Memorandum

To: Andy Cole, North Devon Council
From: Bob Davis/Dave Coles, 24 Acoustics Limited
Date: 2 March 2021
Job: Batsworthy Cross – Noise Issues
Ref: R7792-2 Rev 0

Batsworthy Cross Wind Farm – Noise Compliance Assessment - Noise Levels at locations around Birchwood House: Review of effect of proposed mitigation measures

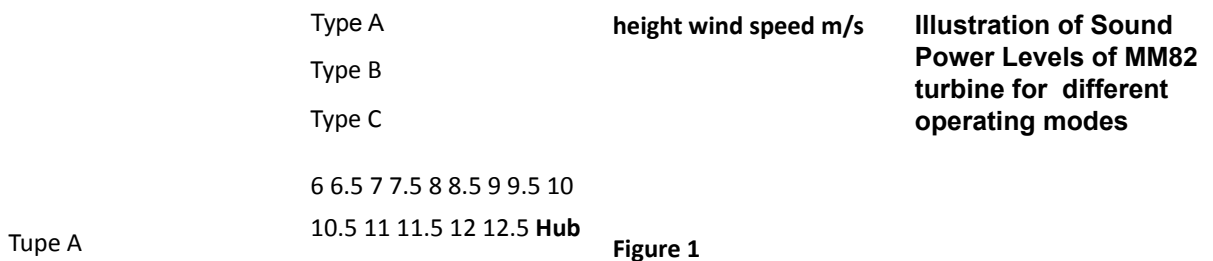
How can predicted noise reductions be ‘expected to be accurate’ if they are ‘very dependent’ on “likely” wind shear values.
